The Commission has issued the enclosed Amendment Nos. 121, 116 and 92 to Facility Operating License Nos. DPR-33, DPR-52 and DPR-68 for the Browns Ferry Nuclear Plant, Units 1, 2 and 3. These amendments are in response to your application dated September 22, 1983 (TVA BFNP TS 191), as supplemented March 20, 1985.

These amendments revise the present pressure-temperature limit curves (Figure 3.6-1) in the Technical Specifications to provide more conservative limiting temperatures for pressure test, heatup, cooldown and core operations which are valid for 12 equivalent full power years of plant operation. On April 12, 1985, we had issued Amendment No. 87 for Browns Ferry Unit 3 which, as an interim measure, had approved the same identical curves for the duration of the present Cycle 6 operations.

SAFETY EVALUATION BY THE OFFICE OF NUCLEAR REACTOR REGULATION

BROWNS FERRY NUCLEAR PLANT, UNITS 1, 2 AND 3

Figure 3.6-1

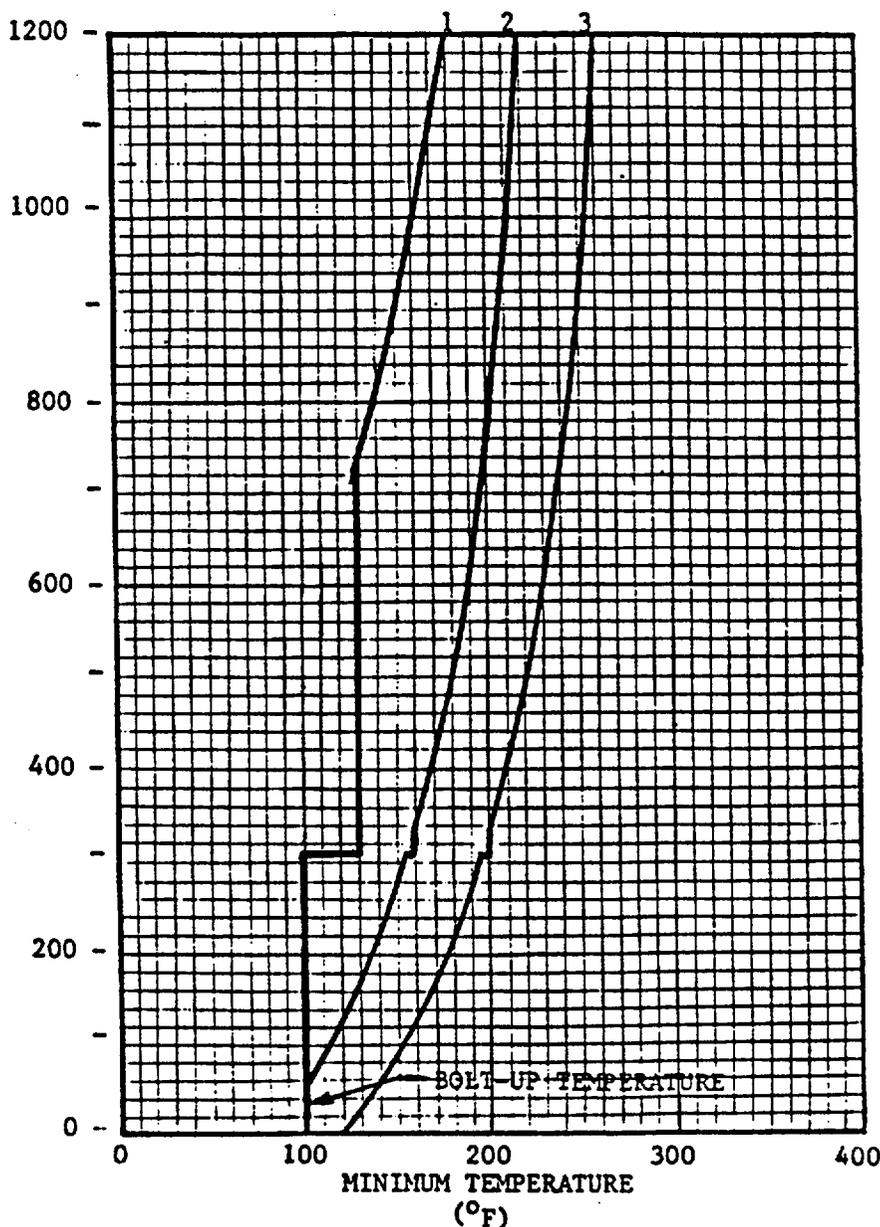
Revise Appendix A as follows:

1. Remove the following page and replace with identically numbered page.

2. The marginal lines on this page denote the area being changed.

Minimum temperature for pressure tests such as required by Section XI. Minimum temperature of 170°F is required for test pressure of 1,100 psig.

Minimum temperature for mechanical heatup or cooldown following nuclear shutdown.

Minimum temperature for core operation (criticality) includes additional margin required by 10CFR50, Appendix G, Par. IV.A.3 which became effective July 26, 1983.

These curves include sufficient margin to provide protection against feedwater nozzle degradation. The curves allow for shifts in RTNDT of the reactor vessel beltline materials to compensate for radiation embrittlement for 12 EFY.

Figure 3.6-1

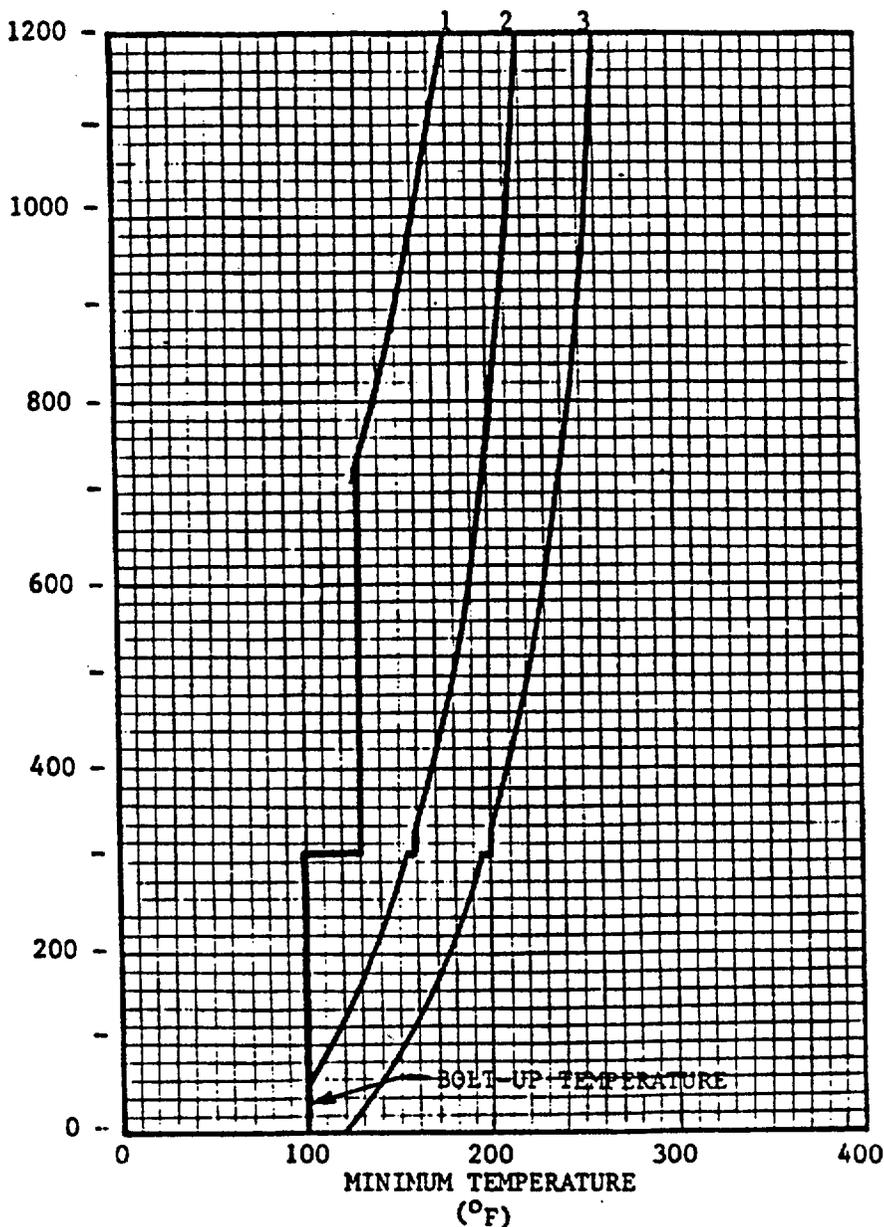
Revise Appendix A as follows:

1. Remove the following page and replace with identically numbered page.

2. The marginal lines on this page denote the area being changed.

Minimum temperature for pressure tests such as required by Section XI. Minimum temperature of 170°F is required for test pressure of 1,100 psig.

Minimum temperature for mechanical heatup or cooldown following nuclear shutdown.

Minimum temperature for core operation (criticality) includes additional margin required by 10CFR50, Appendix G, Par. IV.A.3 which became effective July 26, 1983.

These curves include sufficient margin to provide protection against feedwater nozzle degradation. The curves allow for shifts in RTNDT of the reactor vessel beltline materials to compensate for radiation embrittlement for 12 EFPY.

Figure 3.6-1

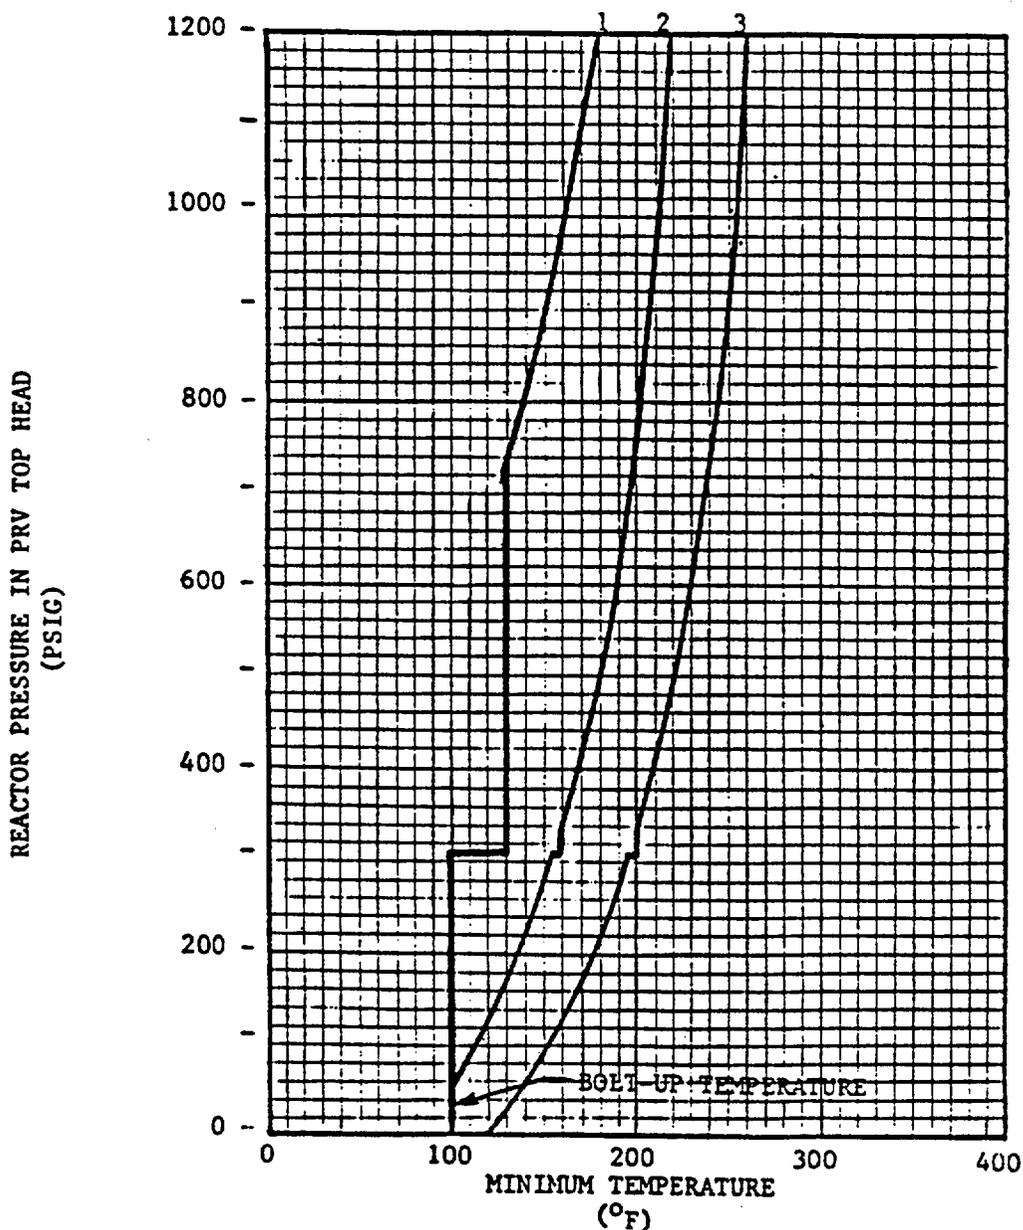
Revise Appendix A as follows:

1. Remove the following pages and replace with identically numbered pages.

2. The marginal lines on the above pages denotes the area being changed.

The fracture toughness of all ferritic steels gradually decreases with exposure to fast neutrons above a threshold value. To adjust for this, the minimum operating temperature vs. pressure curves need to be revised. The present curves in Figure 3.6-1, which were based on a shift in  $RT_{NDT}$  of 30 F, were approved for use through 4.0 EFPY. The Browns Ferry reactor vessels have exceeded this exposure. By application dated September 23, 1983, the licensee proposed revised curves. Our review of this submittal determined that additional information (as described in our letter of January 23, 1984) was needed on the chemical composition and test results on the weld and plate material used to fabricate the reactor vessels. The information requested was provided by TVA'S letter of March 20, 1985. The March 20, 1985 submittal provided clarifying information to support the licensee's materials evaluation and did not significantly change the initial application. Based on the irradiation data, TVA concludes that a 45°F shift in  $RT_{NDT}$  will not occur for at least 12 EFPY of operation. This would cover about the next decade of operation for each Browns Ferry unit.

Curve #1  
Minimum temperature for pressure tests such as required by Section XI. Minimum temperature of 170°F is required for test pressure of 1,100 psig.

Curve #2  
Minimum temperature for mechanical heatup or cooldown following nuclear shutdown.

Curve #3  
Minimum temperature for core operation (criticality) includes additional margin required by 10CFR50, Appendix G, Par. IV.A.3 which became effective July 26, 1983.

Notes  
These curves include sufficient margin to provide protection against feedwater nozzle degradation. The curves allow for shifts in RTNDT of the reactor vessel beltline materials to compensate for radiation embrittlement for 12 EFPY.

Utilizing the method recommended in Regulatory Guide 1.99 Rev. 1 to predict neutron irradiation damage, the neutron fluence estimates calculated by Southwest Research from surveillance capsule dosimetry, the unirradiated RT<sub>NDT</sub> and chemical composition for the limiting beltline welds previously discussed, and RT<sub>NDT</sub> for the closure flange region of 40 F; we have determined that the proposed pressure-temperature limits meet the safety margins of Appendix G, 10 CFR 50 for 12 EFY, and may be incorporated into the plants' Technical Specifications.
